# CIVA Free Known Programme 1 Power Intermediate / Yak-52, Advanced and Unlimited 2018

# **Guidance for competitors**

## The "Known" figures specified by CIVA for powered aircraft in 2018 are:

## **Unlimited power category**

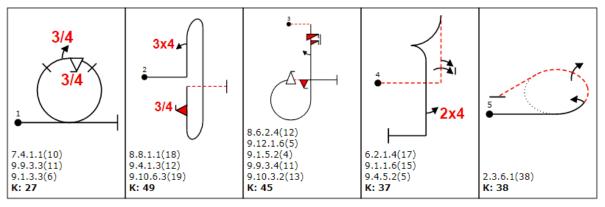
**Note 1:** Unlimited power Figure #3 has been revised from the original version

- $\bullet$  The duplicated 2x4 roll (9.5.4.2) after the spin is now changed to a ½ roll (9.1.5.2)
- The flick-roll pair is now set to opposite directions per Aresti regulations

**Note 2:** With Unlimited power Figure #5 (2.3.6.1) set as a mandatory item, all unlimited Free Known sequences must include a further rolling turn to meet versatility requirements per Section 6 Part 1 para 2.2.1.8
